Proposed Amendment to DA24-O24 - Hotel and Restaurant Lot 2654 (No. 275) Bayview Road, Gap Ridge

RFF Australia acts on behalf of QSD Hire Pty Ltd with respect to the development of the Bayview Hotel and Restaurant, at Lot 2654 (No. 275) Bayview Road, Gap Ridge ('the subject land'). We are pleased to submit this application for an Amendment to the existing Development Approval (DA24-O24) that seeks to amend the general layout of the development within the front portion of the site (hotel bar, restaurant and supporting amenities).

This Application seeks to amend the existing Development Approval of the City of Karratha for minor amendments to the approved site plan. The amendments are concentrated in the front portion of the site, and are summarised as follows:

PROPOSED AMENDED SITE PLAN TABLE OF RELEVANT STATISTICS

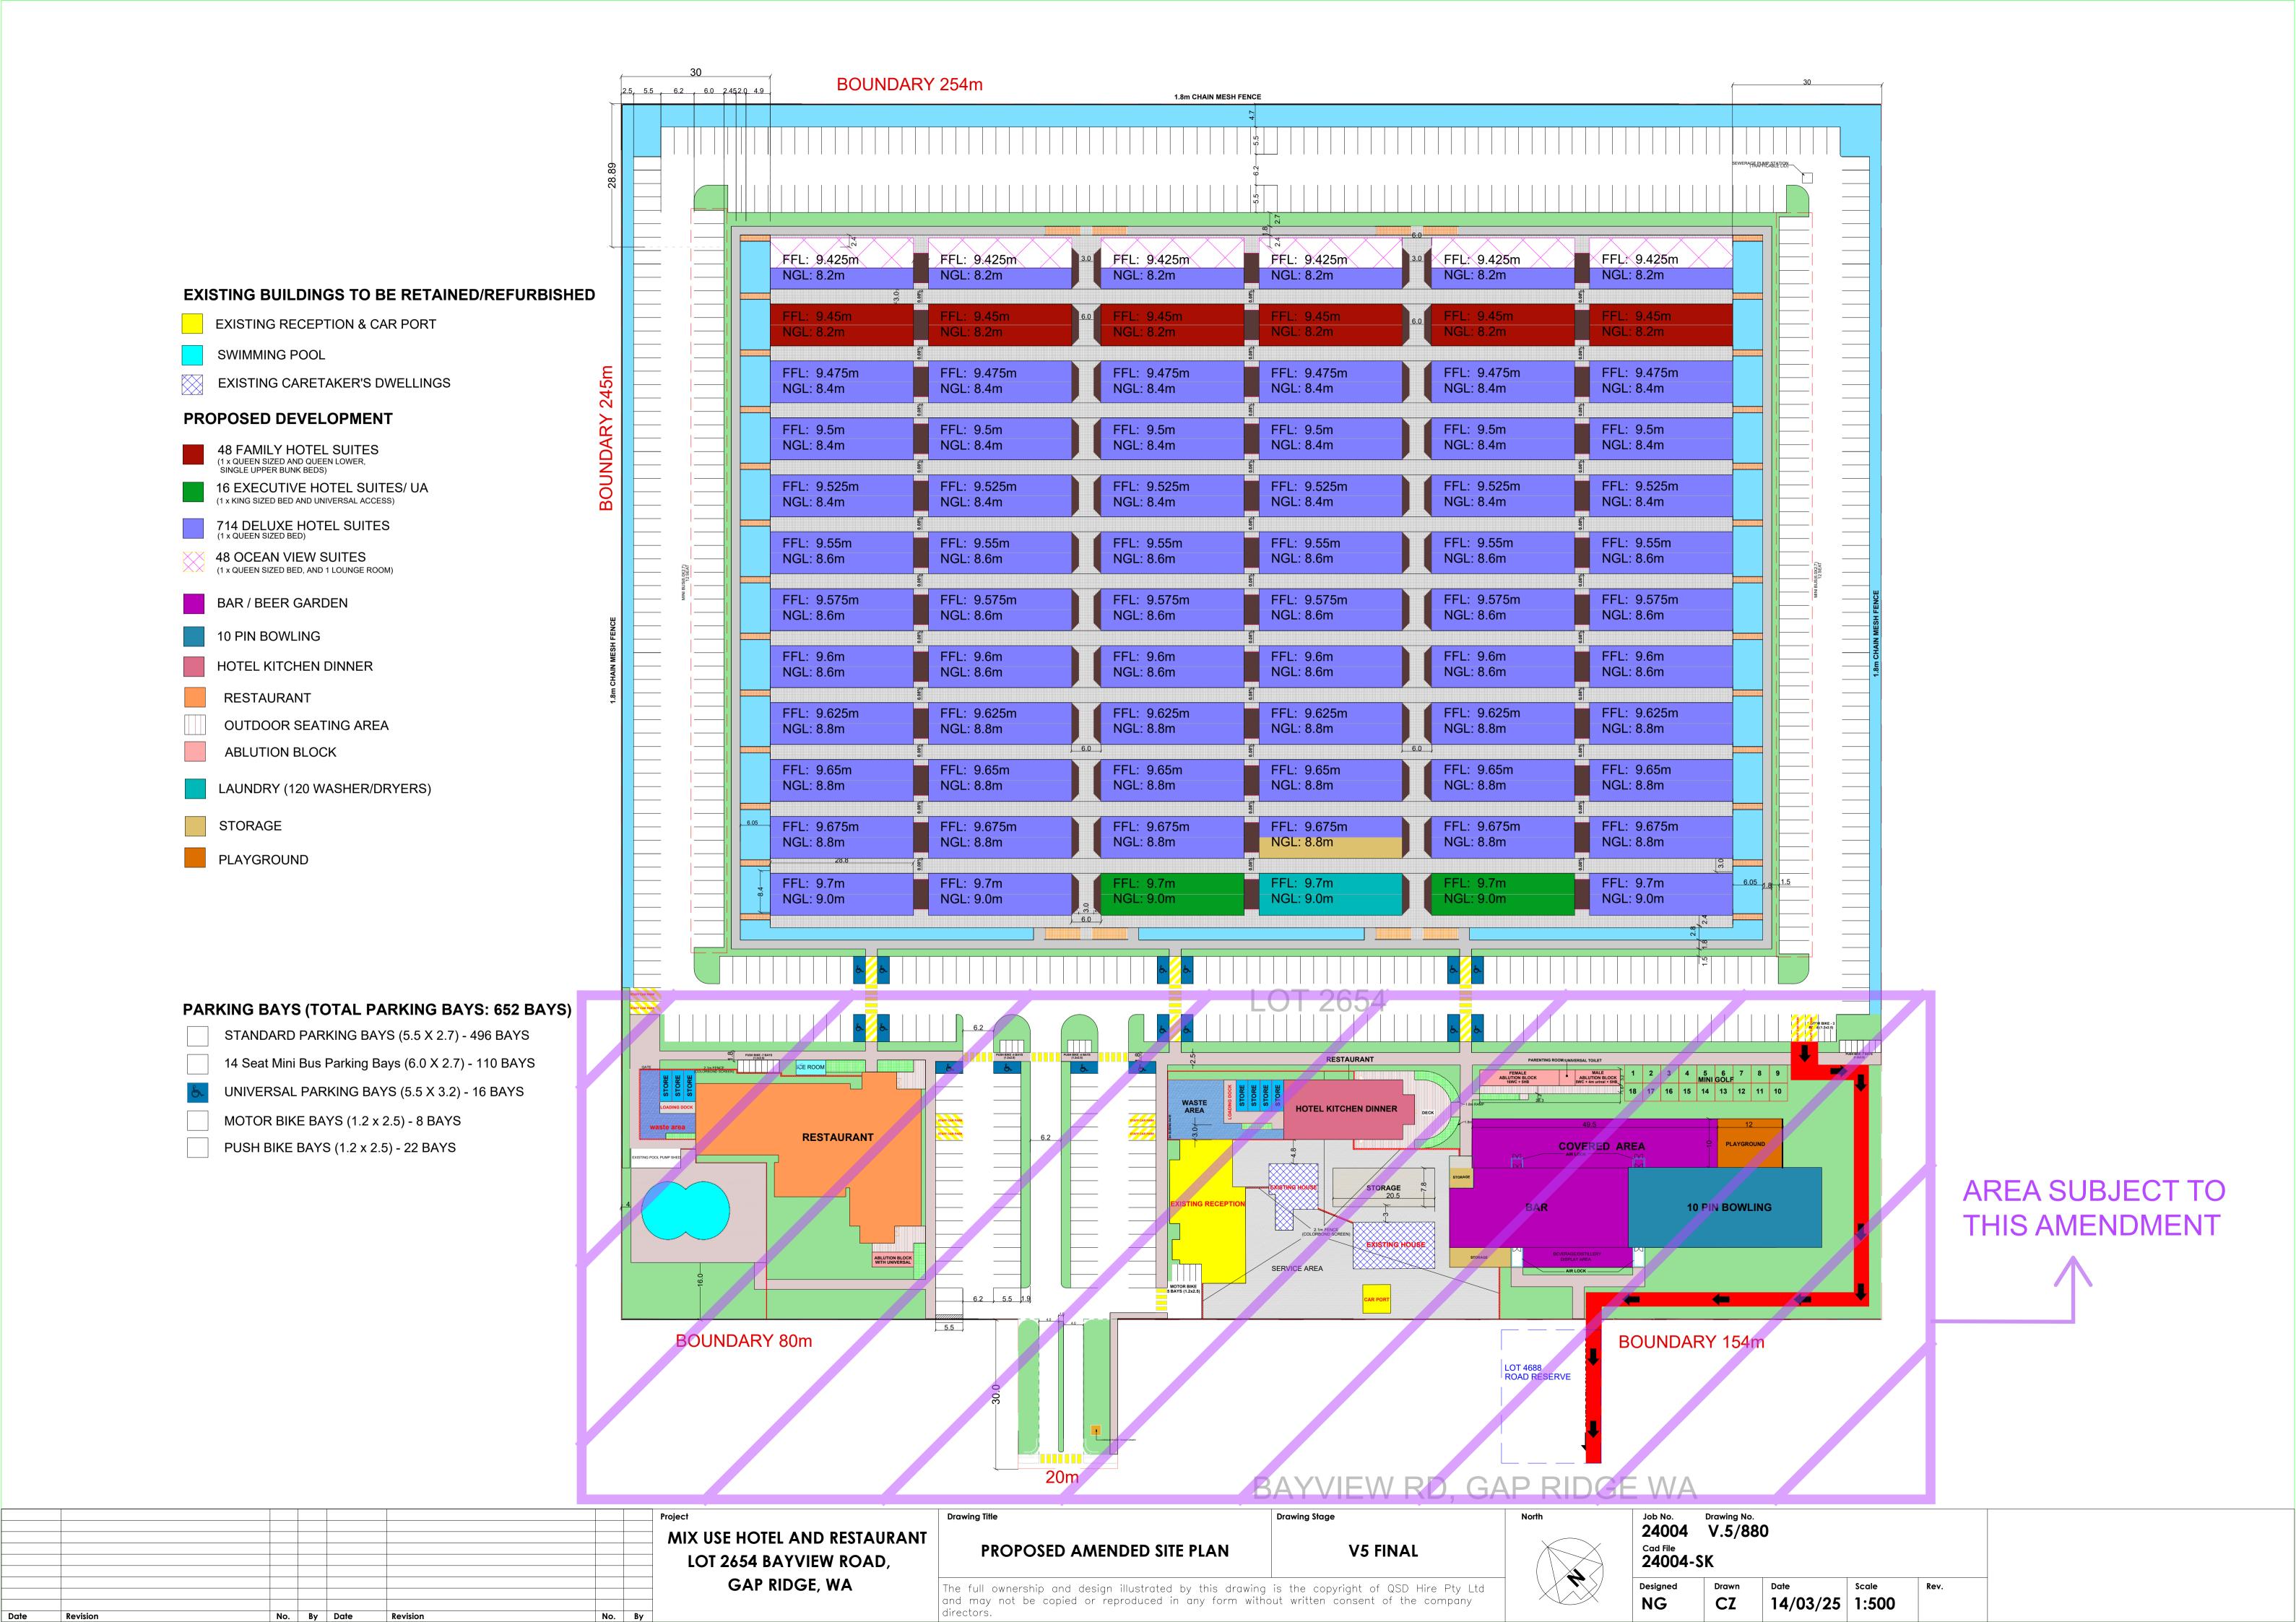
NET EFFECT OF PROPOSED AMENDMENTS

Public Area			
Various Public Buildings Type	AMD - 2	AMD - 1		
	Area Proposed	Area Approved		
Bar and New 10 Pin Bowling Lounge	423 m ²	320 m ²		
Covered Area	490 m ²	678 m ²		
Reception Area	415 m ²	415 m ²		
Restaurant Dinning Area	533 m ²	576 m ²		
Playground Area	117 m ²	100 m ²		
Mini Golf Area	240 m ²	240 m ²		
Total	2218 m ²	2329 m ²		
NET USABLE AREA CHANGE		111 m ²		
		Qty		
Car Park	AMD - 2	AMD - 1		
	Proposed	Approved		
Standard Parking Bays (5.5 X 2.7)	496 BAYS	496 BAYS		
14 Seat Mini Bus Parking Bays (6.0 X 2.7)	110 BAYS	110 BAYS		
Universal Parking Bays(5.5 X 3.2)	16 BAYS	16 BAYS		
Motor Bike Bays (1.2 x 2.5)	8 BAYS	8 BAYS		
Push bike bays (1.2 x 2.5)	22 BAYS	22 BAYS		
TOTAL BAYS	652 BAYS	652 BAYS		
NET PARKING CHANGE	0			
Vienel Irone et	AMD - 2	AMD - 1		
Visual Impact	Proposed	Approved		
Built Form and Façade From Street	Not visible 100% Screened via landscaping	Not visible 100% Screened via landscaping
